# Access Compliance Report

## Public Rights-of-Way

### (Curb Ramps)

Intersection ID: 10025500	Main Street: E MARTIN LUTHER KING JR BLVD	Cross Street: N/A	Location: W
ADA ID: 013A8851399C	Ramp Type: Directional	Initial Pass/Fail: Fail	Overall Compliance: No
Codes/Mitigation Info/Possible Solution		Field Measurements/Component Compliance	
Severity Score: 13.75

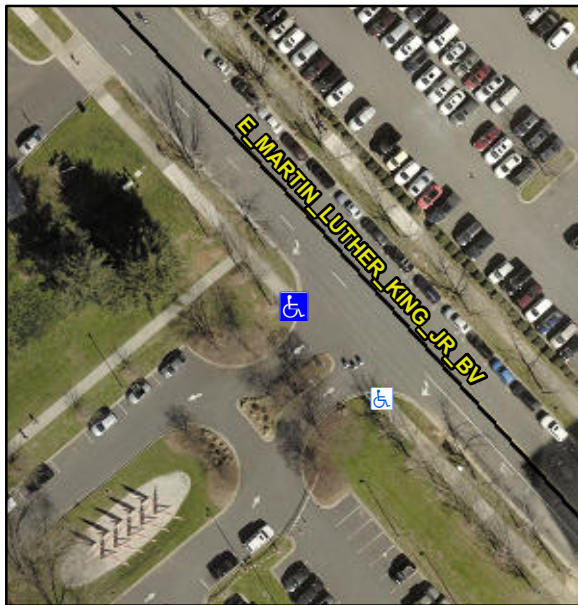
**Remove & Replace Entire Ramp.**

**R304.2.2**

Compliance	Description	Data	Compliance	Description	Data
N/A	Ramp Length (in)	87.0	N/A	Grade Break?	N/A
Yes	Ramp Width (in)	96.0	N/A	Grade Break Slope (%)	0.0
No	Ramp Slope (%)	8.6	N/A	Grade Break XSlope (%)	0.0
Yes	Ramp XSlope (%)	2.1			
N/A	Flare Type LT	N/A	N/A	Flare Type RT	N/A
N/A	Flare Slope LT (%)	N/A	N/A	Flare Slope RT (%)	0.0
N/A	Flare Traversable LT?	N/A	N/A	Flare Traversable RT?	N/A
N/A	Landing Length (in)	0.0	N/A	DWS Provided?	N/A
N/A	Landing Width (in)	0.0	N/A	DWS Contrast?	N/A
N/A	Landing Slope (%)	0.0	N/A	DWS Length (in)	N/A
N/A	Landing X Slope (%)	0.0	N/A	DWS Full Width?	N/A
N/A	Landing Curb? (Y/N)	N/A	N/A	DWS Offset LT (in)	N/A
N/A	Shared Landing?	N/A	N/A	DWS Offset RT (in)	N/A
N/A	Gutter Ponding?	0.0	N/A	Gutter Slope (%)	N/A
N/A	Gutter Lip Ht (in)	0.0	N/A	Gutter X Slope (%)	N/A
N/A	Painted X Walk1?	No		Road Slope (%)	3.4
	X Walk 1 Direction	To SE		Road X Slope (%)	3.4
	X Walk 1 Width (in)	N/A		Clear Space?	N/A
